ADDENDUM
NO. 3

June 2, 2020

Additions & Renovations to Lawrence Central High School
7300 E.56th St.
Indianapolis, IN 46226

PREPARED BY SCHMIDT ASSOCIATES FOR:
LAWRENCE CENTRAL HIGH SCHOOL RENOVATION
LAWRENCE TOWNSHIP, M.S.D. OF

A. Sheet Number SF1KR

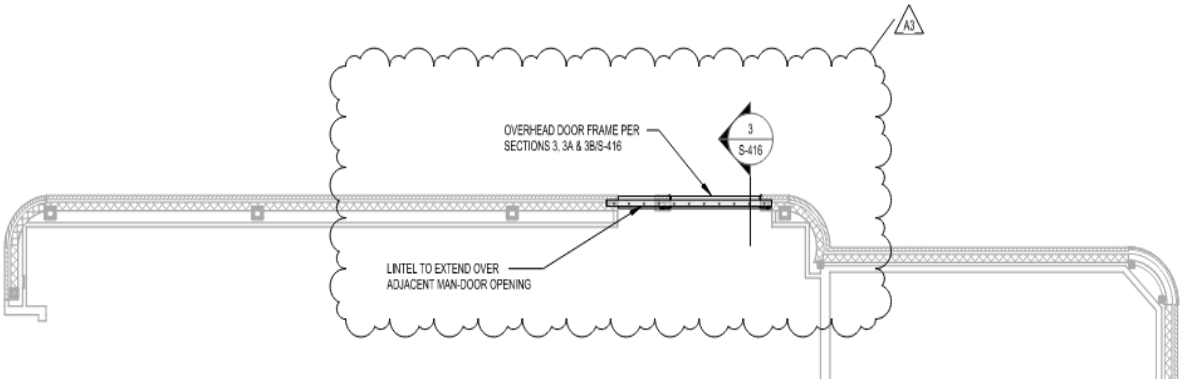
1. In 2/SF1KR, at the eastern overhead door, change the section callout to 3/S-416 and add two notations as shown below:

G. Sheet Number A-210

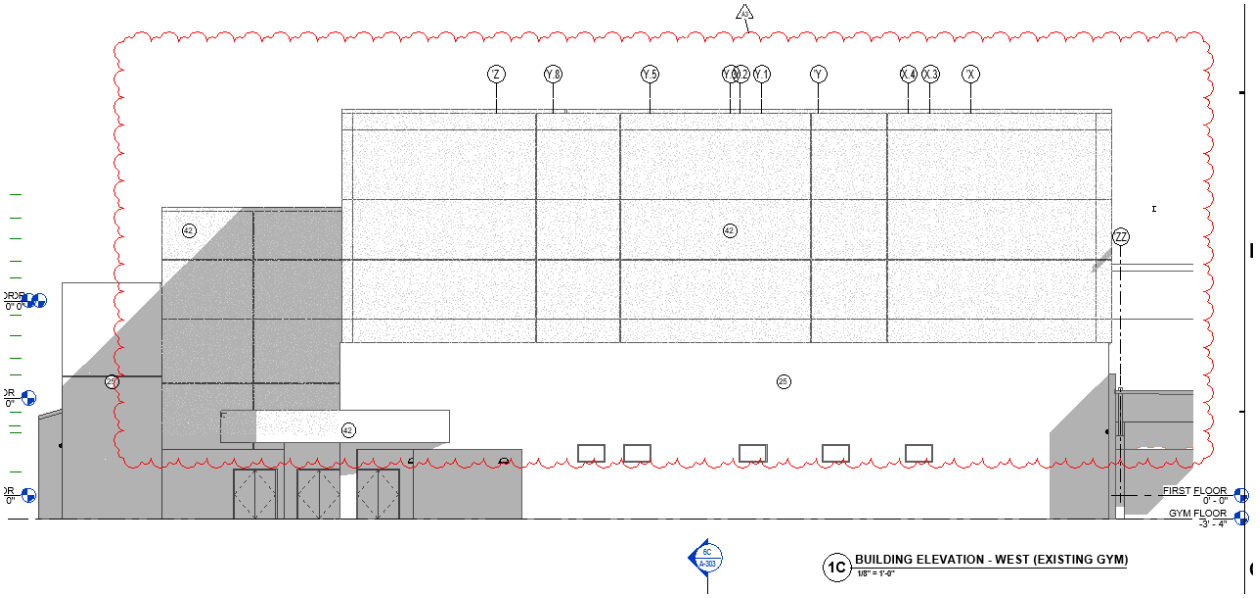
1. DELETE Drawing 1C and replace with drawing below:

K. Sheet Number A-604

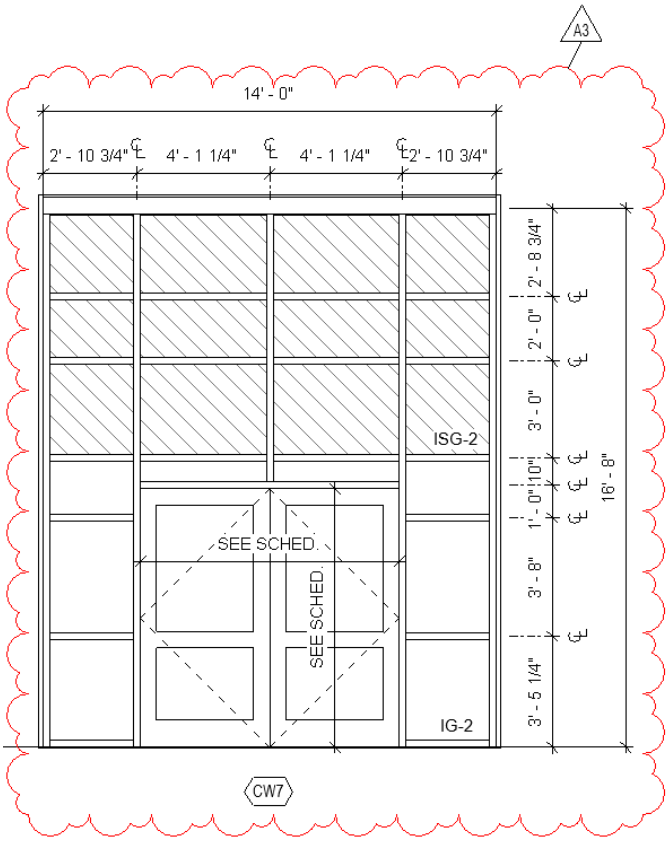
1. DELETE Curtain Wall Elevation CW7 and replace with the following:

B. Sheet Number IN1B3

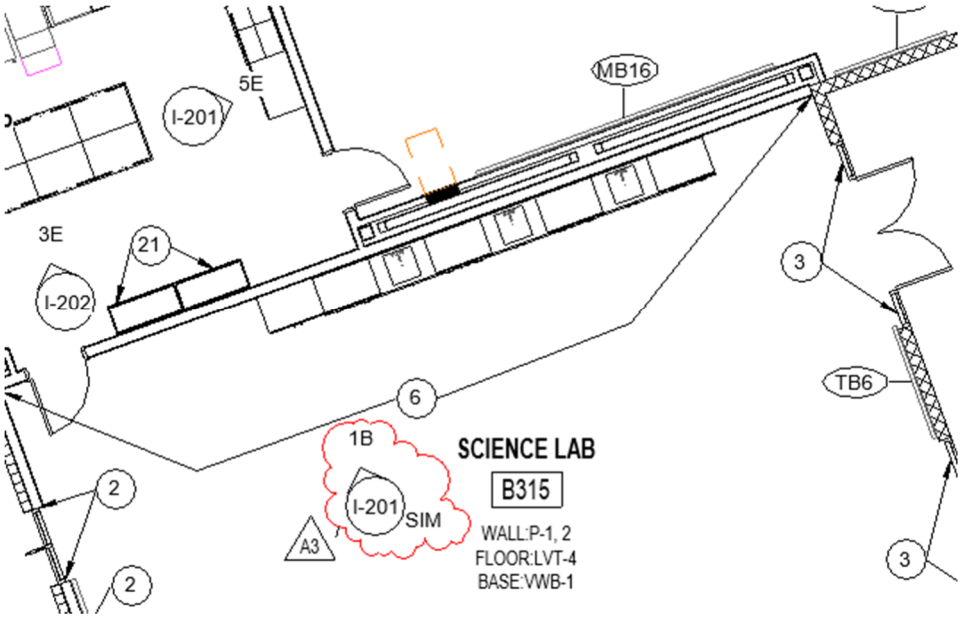
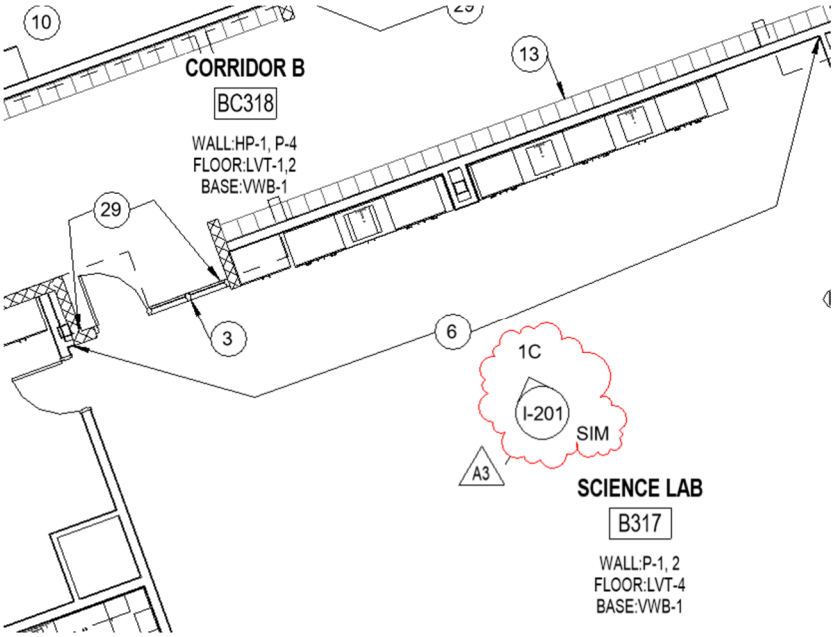
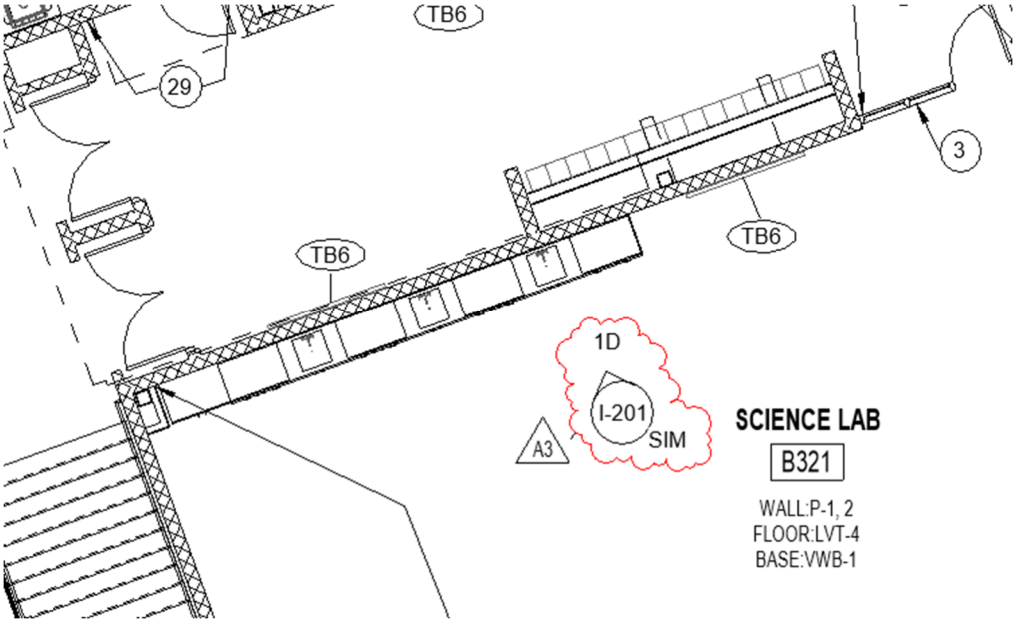
1. ADD Elevation Markers as shown below:

5D TYPICAL SCIENCE PREP CASEWORK ELEVATION 1
1/4" = 1'-0"

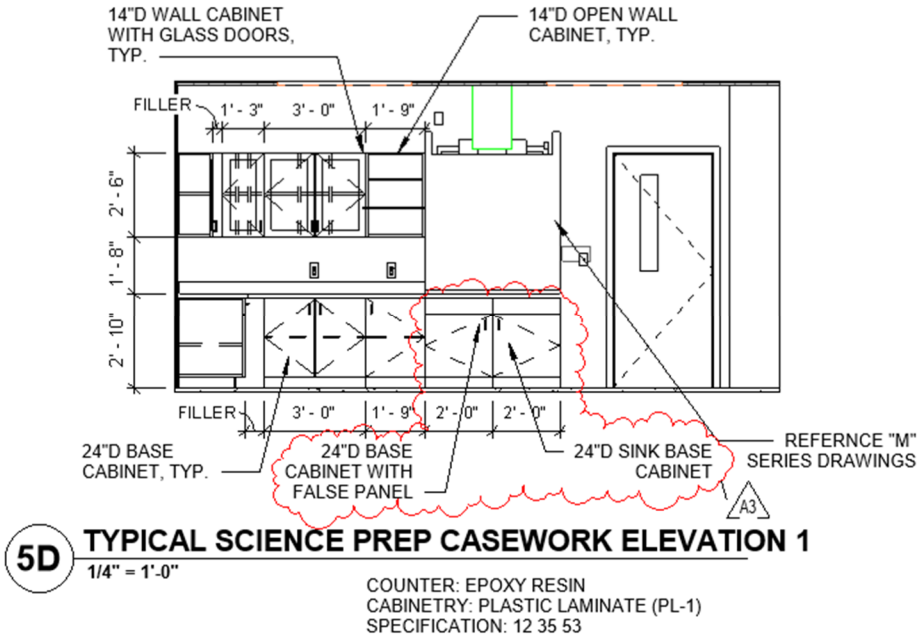
1. MODIFY Elevation as shown below:

3A SCIENCE PREP ROOM (CHEMISTRY) CASEWORK ELEVATION 1
1/4" = 1'-0"

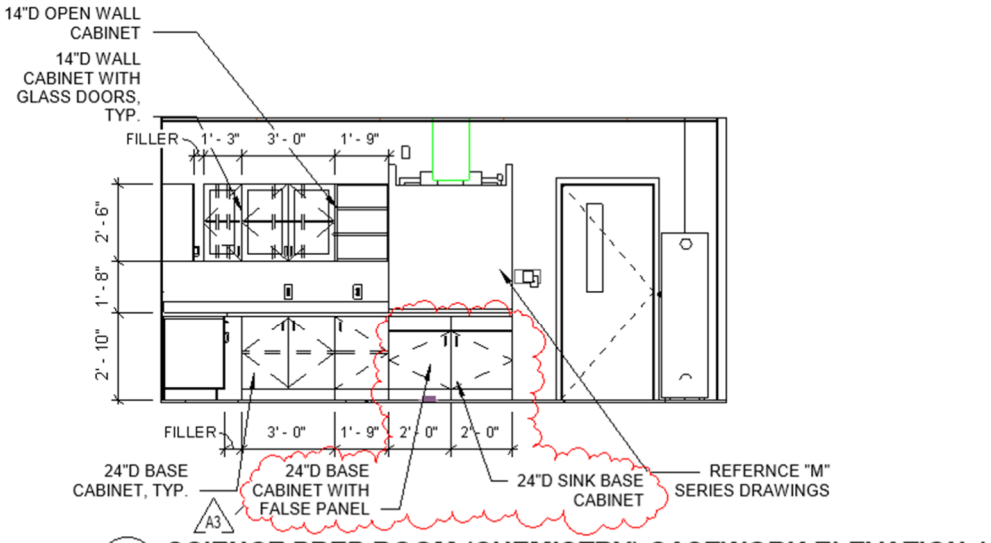
1. MODIFY Elevations as shown below:

A. Drawing Number PF1A0

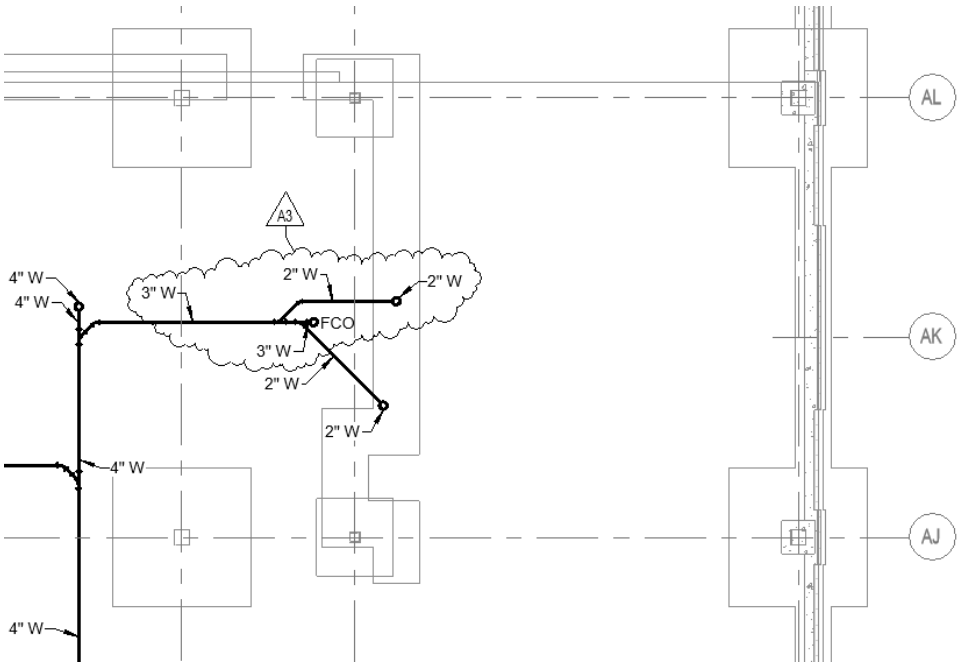
1. MODIFY underslab waste piping shown on 2A as shown below:

B. Drawing Number PF1A0

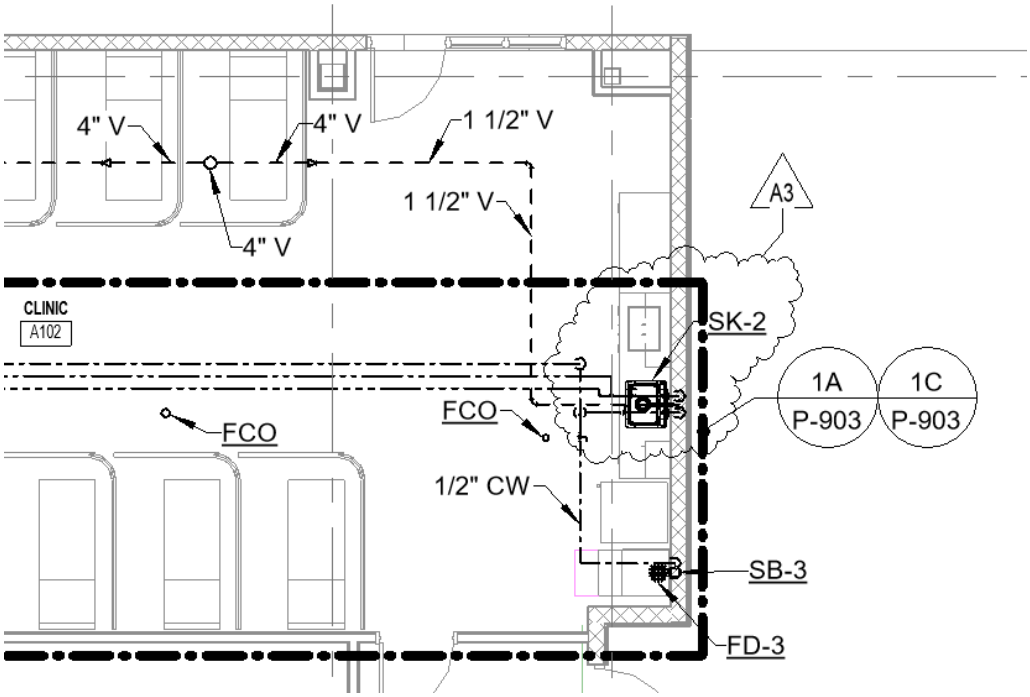
1. MODIFY Clinic A102 sink location and piping layout as shown below:

C. Drawing Numbers PP1B1, PP1B2, PP1B3

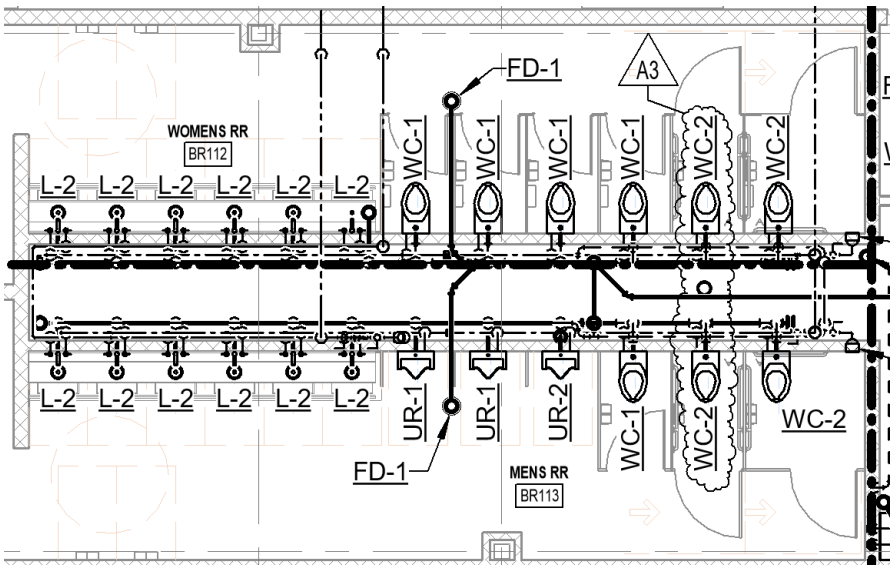
1. DELETE AND REPLACE water closet fixture type WC-1 with WC-2 in ambulatory stalls of Unit B gang restrooms on First, Second, and Third floors. See below for typical:

2. **Drawing Number P-903**

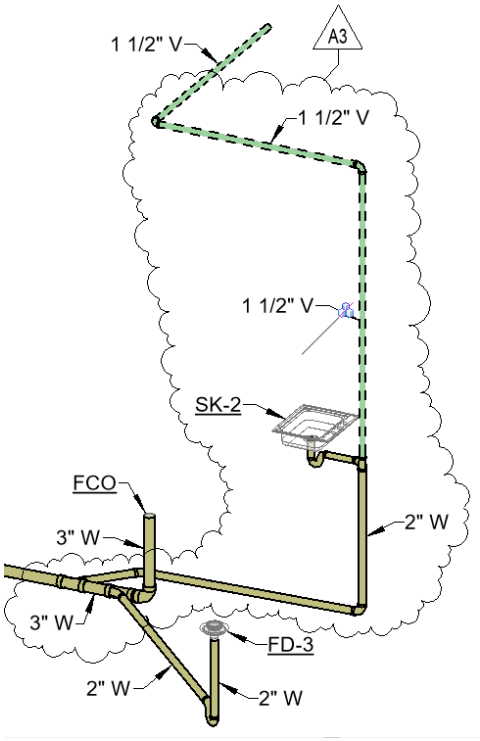
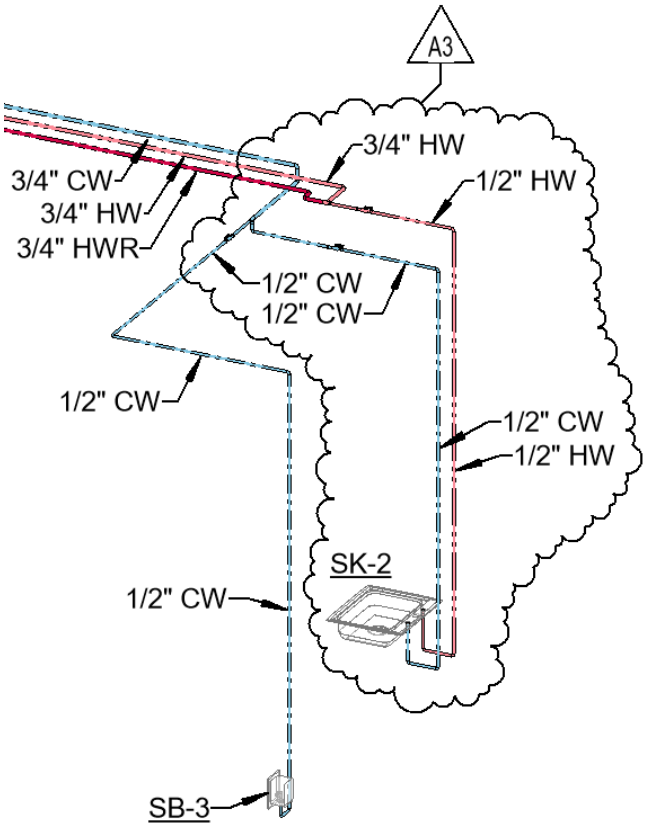
a. MODIFY 1A and 1C for Clinic A102 sink location and piping layout as shown below:
